ADAME = TECH PRODUCT CHANGE NOTIFICATION						
PCN No.: EC-20250906-PCN-02	PCN Doc No.: PCN-202509-078	Date Issued:	2025/9/6			
Part Number or Series: HBHR-B-XX-VG-SMT		PCN Effective Date:	Not affected			
Customer: (If applicable)		P/O No.: (If applicable)	Not affected			
Гуре of Change:	■ Mfg location Change / Qualification / Country of Origin (COO)	Last Time Buy Date:	Not affected			
	■ Design Change / Data Sheet Spec Change	Zaot Tillio Day Dato!				
Fraceability Marking/Date code: No	o change	Last Time Ship Date:	Not affected			
Replacement Part Number: HBHR	-B-XX-VG-SMT-Y-PT	Sample Availability Date:

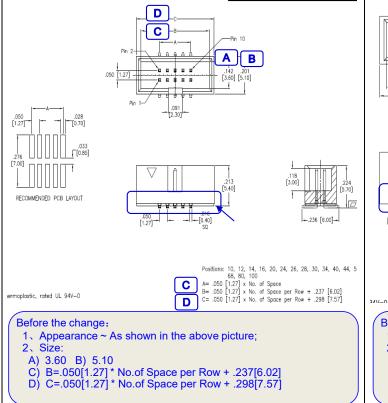
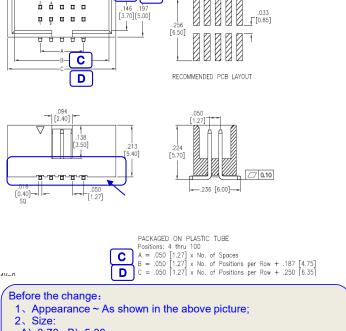
•	our production flexibility and ensur entioned part(s). This strategic adju		be expanding manufacturing to efficiency and reliability in meeting			
Reason for Change: This change is implemented to optimize our global manufacturing capabilities, allowing us to dynamically allocate production resources based on current order conditions and market needs, ensuring timely delivery and quality consistency.						
mpact of Change: P/N change, There are slight differences in appearance and size;						
Details: See below						
Before	Change	After Change				
B UPDATED DRAWING C B Pin 10 A A B 142 201 [3.60] [5.10]		A B D D D D D D D D D

- A) 3.70 B) 5.00 C) B=.050[1.27] * No.of Positions per Row + .187[4.75] D) C=.050[1.27] * No.of Positions per Row + .250[6.35]
